HISTORIC AND DESIGN REVIEW COMMISSION

December 05, 2018

HDRC CASE NO: 2018-567
ADDRESS: 555 CLUB DR
553 CLUB DR
LEGAL DESCRIPTION: NCB 6757 BLK G LOT 35 N 25 FT OF 34
ZONING: MF-33
CITY COUNCIL DIST.: 7
DISTRICT: Monticello Park Historic District
APPLICANT: Donna Crabtree/Sophus Properties
OWNER: Ryan and Yanzhi Kwong
TYPE OF WORK: Window replacement
APPLICATION RECEIVED: October 26, 2018
60-DAY REVIEW: December 25, 2018
REQUEST:

The applicant is requesting a Certificate of Appropriateness for a window master plan, including replacement, relocation, and repair – in response to the commission action issued at the July 18, 2018, hearing.

Front

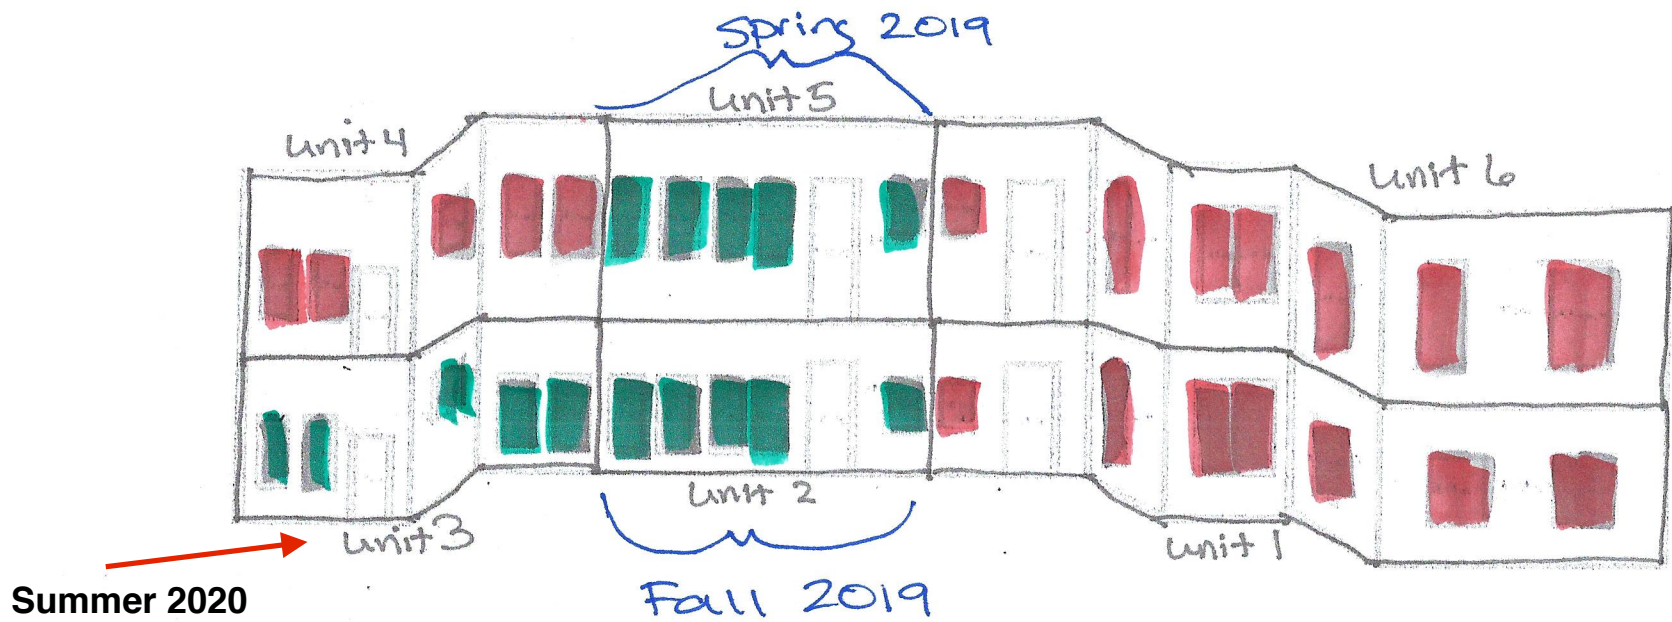
- c. WINDOW REPLACEMENT – The applicant has proposed to repair and relocate all remaining metal casement windows to front street-facing façade. The side and rear façades will be fully vinyl. While the Historic Design Guidelines notes that windows should first be repaired in-place and then replaced in-kind, staff finds that the applicant has responded positively to the feedback provided by the commission and proposed an appropriate plan that keeps all remaining metal casement windows on-site. However, there is a discrepancy between the existing metal casement windows and the proposed amount of windows to remain; staff finds that that at-least 43 metal casement windows should be remain on-site per the original window count.

Staff recommends approval of the window master plan with the stipulation that at least 43 metal casement window remain on the site, per the original count on July 18, 2018. At this time, the master plan depicts only 26 metal casement windows on the front façade with remaining 52 windows to be replaced with vinyl on the side and rear.

Left SIDE

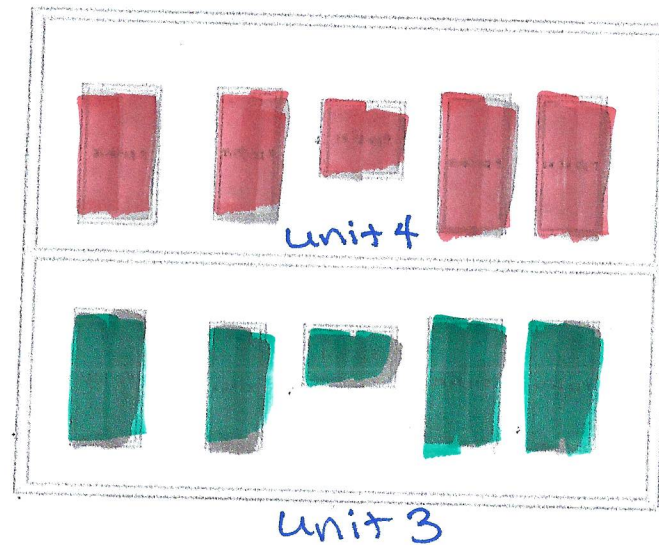
OLD casement to be replaced with vinyl.
